HARTING Product Change Notification

PCN/17/002/C+N

Title: Redesign M12 X-coded Insulation Body - External

Connectors Assembly

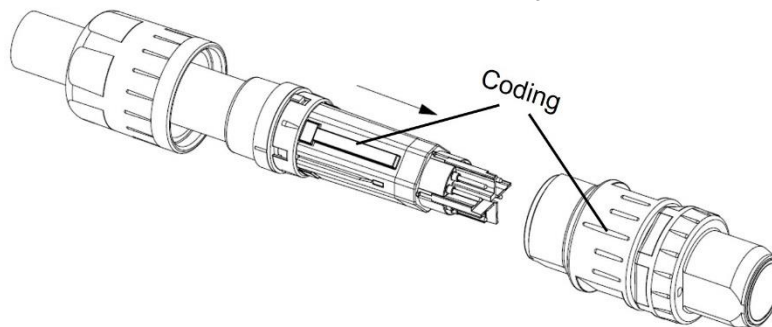
Implementation of an additional rib at the insulation body of male X-coded M12 connectors
